From: [Eli Z Tsarovsky](#)
To: [Plan Commission Comments](#)
Subject: Plan Commission - 12.12.22 - Agenda Items 6-8
Date: Monday, December 12, 2022 9:27:37 AM
Attachments: [Lake Street Garage Committee Report \(1\).pdf](#)

My name is Eli Tsarovsky and I am the President of the Campus Area Neighborhood Association. I am emailing you all today in opposition to the current plans for the 415 N Lake Street Redevelopment in the 2nd Ald. Dist.

Lake Street Garage Steering Committee Report

November 21st, 2022

Alternate Layout

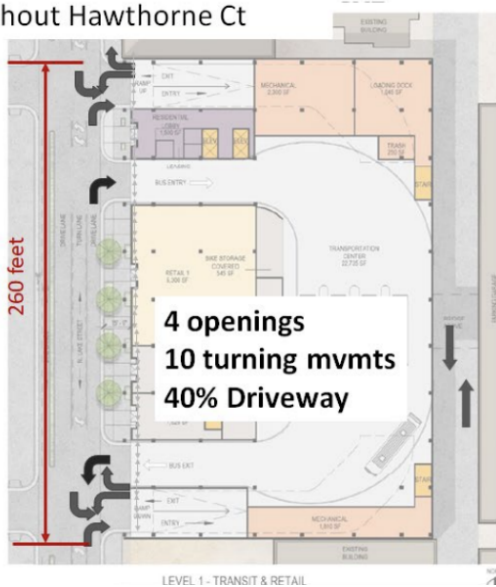
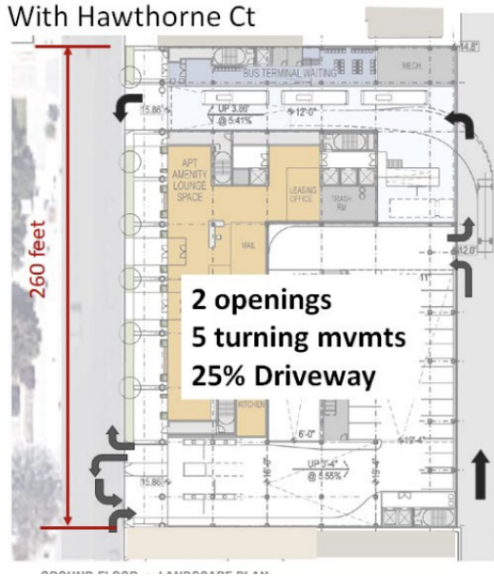
The traffic flow of the current proposal requires intercity buses to cross important, busy lanes of traffic that include **the Major BRT (Bus Rapid Transit) Lane, the unprotected Bike Lane, and the Major Sidewalk**. This is a major logistical flaw as this presents lots of opportunities for major backups on University Ave due to buses not being able to cross the lanes of traffic and a higher risk of accidents due to the Hawthorne Ct functioning as an alleyway and not being a controlled intersection. Not to mention University Ave is a much faster street than Lake Street and increases the risk of accidents like fender benders and bikers being hit during rush hour traffic. The development needs to use Lake Street for buses because it is a controlled intersection with a stoplight as compared to the Hawthorne Ct entrance which has no traffic signals. Additionally, the East Campus Mall BRT Spot can be inferred as a major bus stop for students commuting across campus. The three major residence halls are within a couple of blocks of this spot. Blockages at the Hawthorne Ct entrance will disrupt this major BRT system hub.

seems too complex at the moment. The proposal does not seem to completely address everything. The entrances for residential parking are on the same side as the Van Galder Bus entrance. This mix of traffic seems problematic with bus schedules and the residential experience. If there is a queue that wraps around the corner, this will affect the BRT lane and Metro Bus lane. There is also a need for more entrances and exits to accommodate queues during special events.

- Moving the entrances to the bus terminal and parking to Lake Street
- Creating a Transportation plan that considers all modes of transportation on the site
- Using this project to activate Hawthorne Court with public art, lighting, and cameras
- Make the bus terminal part of a covered part of Lake Street.
- We need a complete Traffic/Environmental Study that considers the impact on local businesses, existing apartments, and all current modes of traffic circulating through this site.

Without Hawthorne Ct

The alternative layout provided by the City of Madison Transportation Department
